Appl. No. 10/801,180
Amendment dated March 9, 2005
Reply to Office Action dated September 9, 2004

ANNOTATED SHEET SHOWING CHANGES

Figure 1

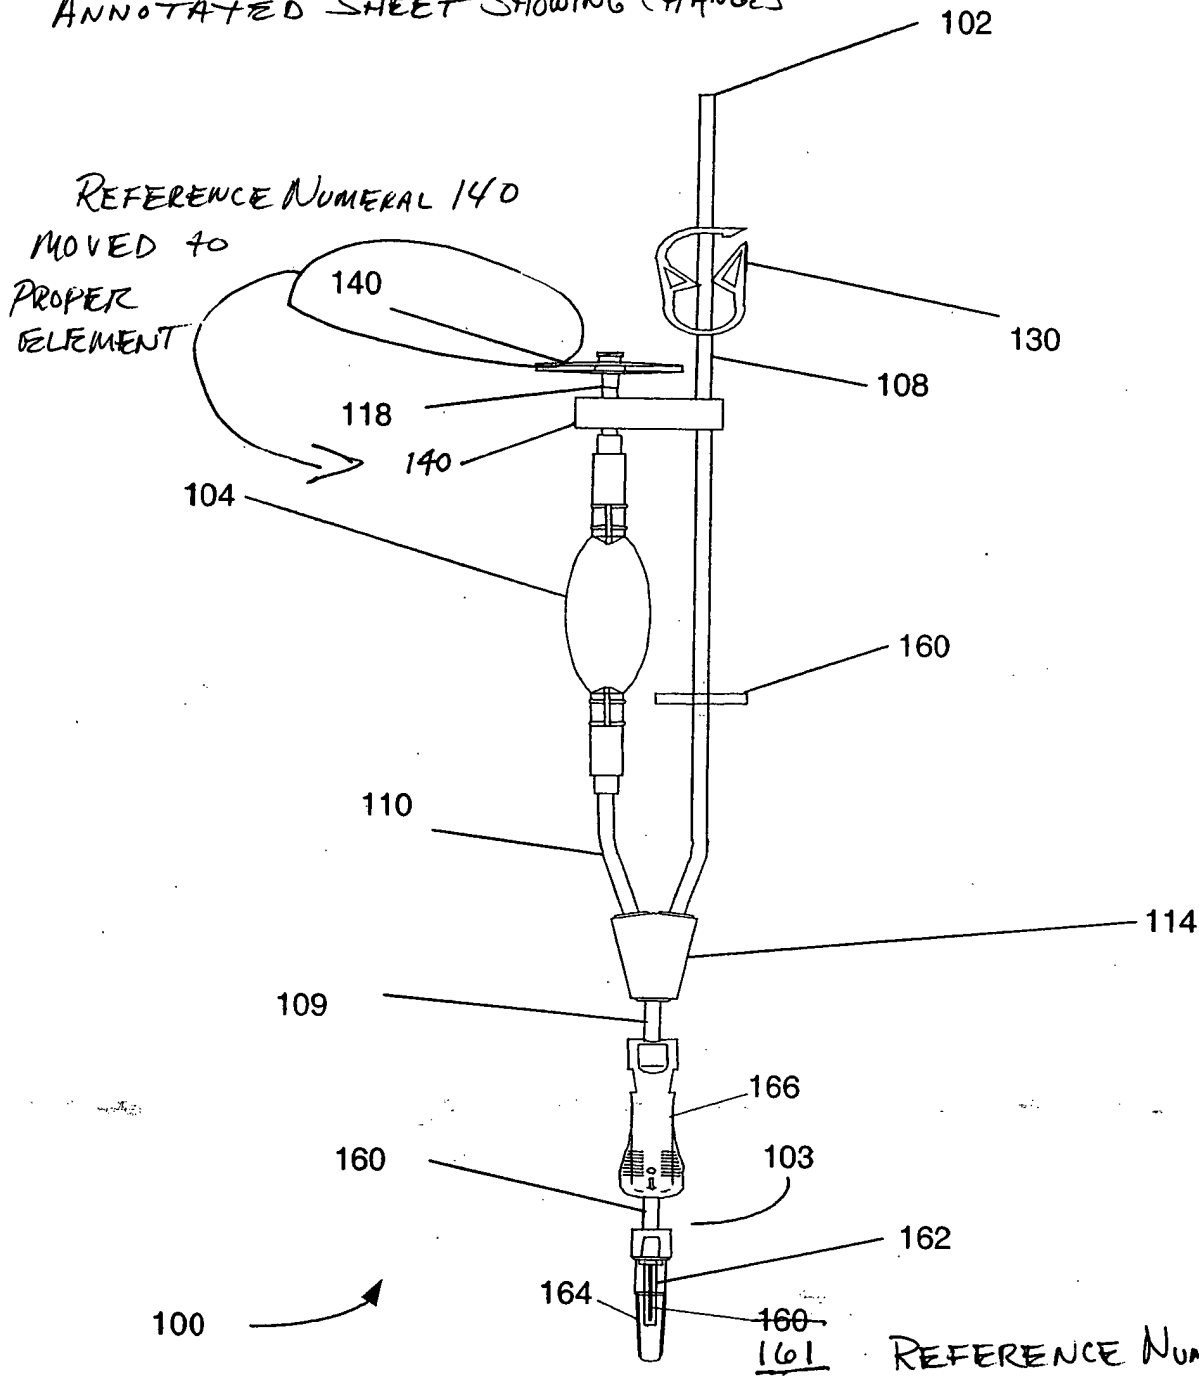
The attached sheets of drawings include changes to FIGS. 1 and 4. The attached sheets replace the original sheets showing FIGS 1 and 4. In both FIGS. 1 and 4, the same two changes are made: 1) reference numeral 140 erroneously pointing to the vent in the original drawings, has been moved to properly indicate the clamp located upstream to the vent; 2) the second appearance of reference numeral 160 (indicating the spike) has been changed to 161 to avoid confusion with the one-way valve, also originally numbered with 160.

Figure 4

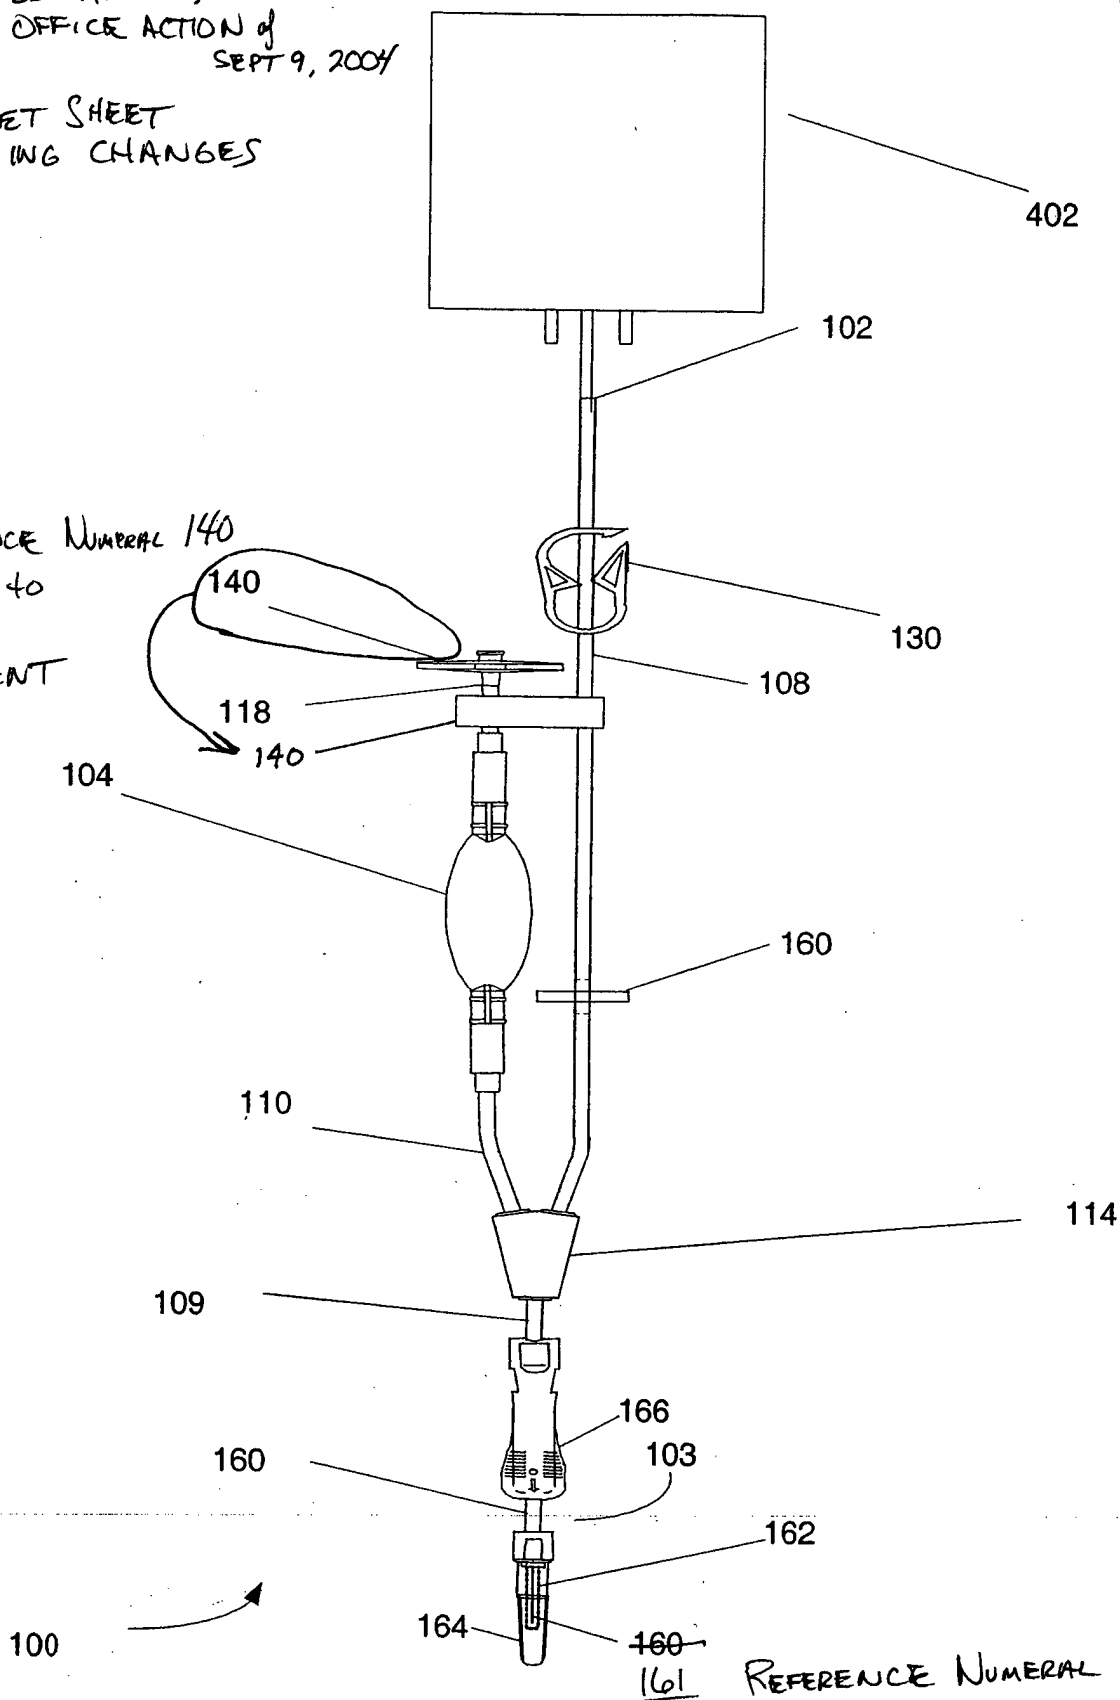
REFERENCE NUMERAL 160
 CHANGED TO 161
 TO CORRECT DOUBLE
 NUMBERING
